TECHNICAL BULLETIN

DS7, R5's, RD250, RD350

CLUTCH, Elimination of Slipping

CLUTCH, Elimination of Slipping (cont.)

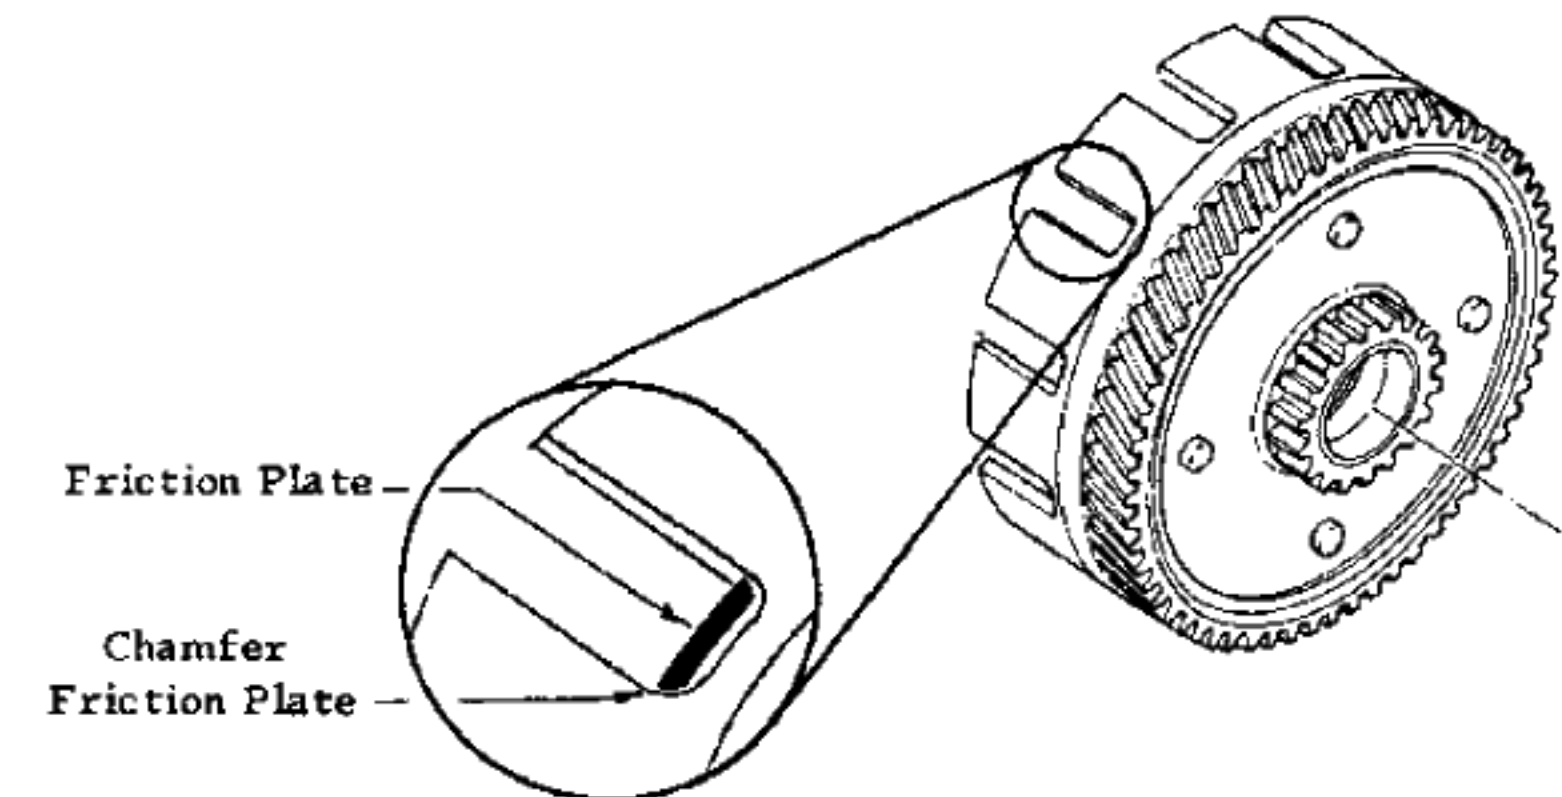
Clutch assemblies on above models have been redesigned to reduce clutch slippage. This change consists of replacing the clutch boss and clutch plates and increasing the number of friction plates from six (6) to seven (7). See table below for both old and new parts list.

The clutch must be assembled with the first friction plate against clutch boss. See drawings below.

When clutch is fully assembled with pressure plate and spring screws installed, check to see if first friction plate is touching clutch hub (Primary Driven Gear Complete). If friction plate is touching, it will be necessary to chamfer edges of friction plate to provide clearance. Do not remove metal from corners of clutch hub. See drawing below.
